## POLICY REPORT DEVELOPMENT AND BUILDING

SUBJECT: CD-1 Rezoning - 2960-2990 Nanaimo Street

2960-2990 Nanaimo Street  
PROPOSED CONDITIONS OF APPROVAL

**1**  
NORTH ELEVATION  
1/8" = 1'-0"

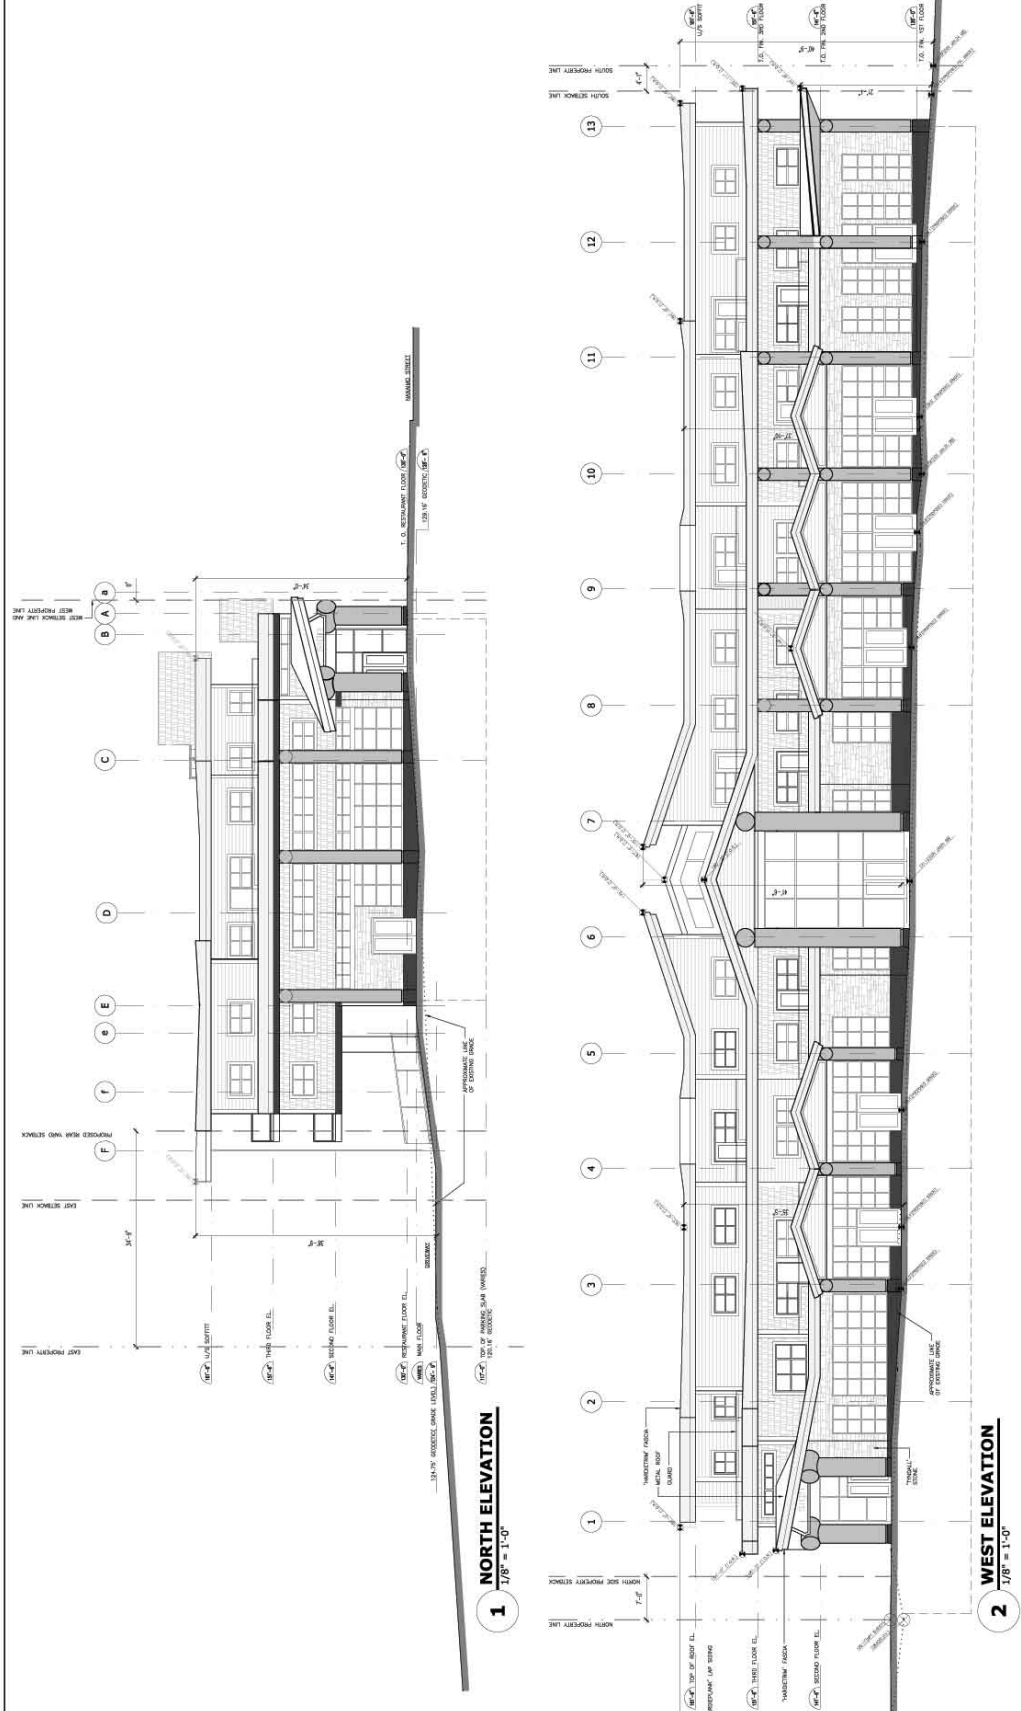
- (i) design development to the Grandview elevation to improve integration with overall building massing;

- (ii) design development to the roofline to simplify and strengthen its expression;

- (v) design development to the public realm on Nanaimo Streets, Grandview Highway as well as the east parking area;

Note to Applicant: This can be achieved by providing a similar setback at the north side of the third floor as the west elevation. Screening of parking and any proposed mechanical equipment should be proposed. The upper two floors should have visible support at the northeast corner. A continuation of the wood columns may be appropriate.

Note to Applicant: Areas of apparent symmetry should be resolved to be symmetrical, especially at the Nanaimo Street entry. The roof form should express the overall building form, and not necessarily the location of balconies. The uppermost gable style appurtenance at the Nanaimo Street elevation should be extended further to the east to have a strong appearance from all view points.

**1 SITE PLAN**  
SCALE: 3/32" = 1'-0"

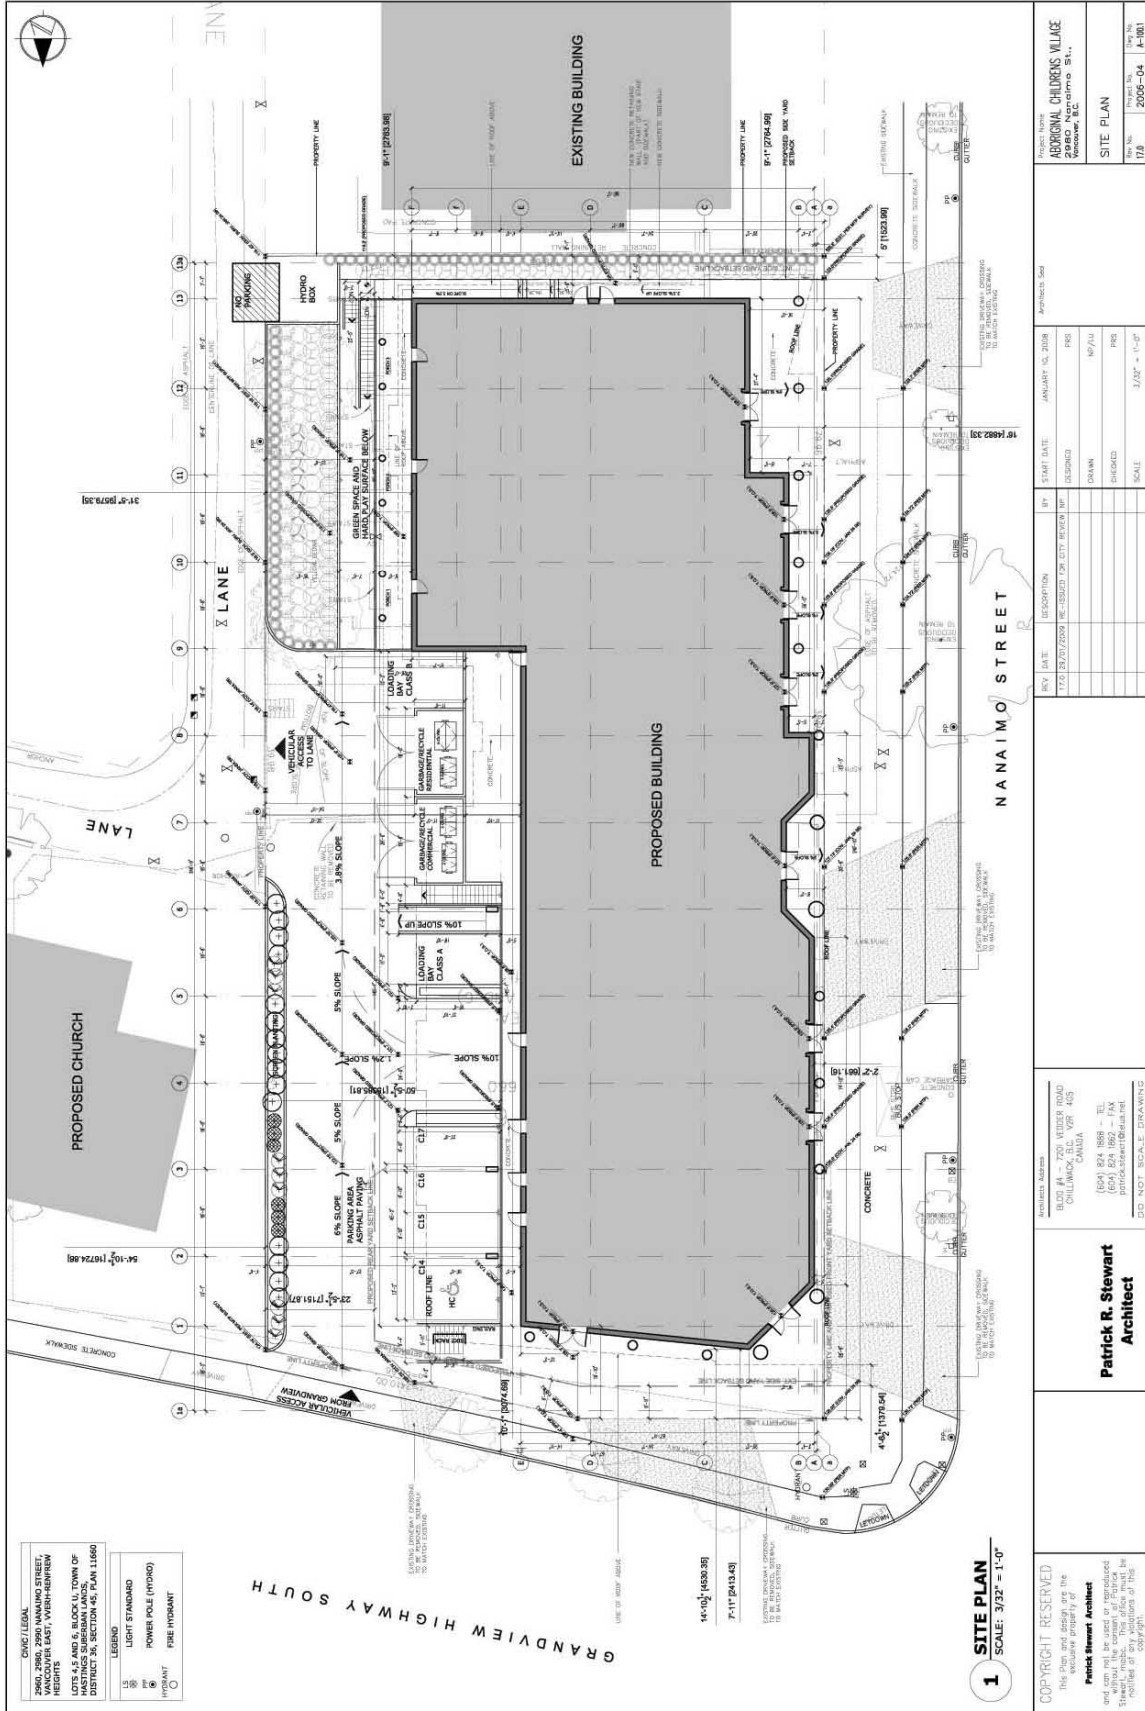
Note to Applicant: The retail entry at Grandview Highway must meet the sidewalk grade. This may require localized interior level changes. Grades, and the requirement of any retaining walls at the parking are must be clarified. At the south east Play Space clarify the direction of stair travel, and stair access on the Site Plan.

Note to Applicant: This can be achieved by coordinating and clearly illustrating all significant landscape items and required setbacks, on the Site Plan. The drawing should include the extent and type of paving, both new and existing, the proposed street trees, the number and rise of stairs, and any retaining walls. Identify the all street furniture or fixtures. A flush planter should be provided at the amenity area entry, approximately between gridlines 12 and 13. The east elevation must show mechanical vents, if any, and proposed screening. The large concrete walls should be detailed with reveals, and climbing vines, if possible. CPTED issues, especially at the stair to the lane adjacent to the garbage area, must be addressed.

- (viii) design development to achieve a coordinated resolution of the garbage and loading areas;

Note to Applicant: The loading and garbage areas should be screened in an attractive and coordinated manner. Provide details of the garbage enclosure construction, and illustrate areas of landscaping on the Site Plan. The design should reduce opportunities for crime, and have strong consideration of personal safety of residents accessing the garbage enclosure.
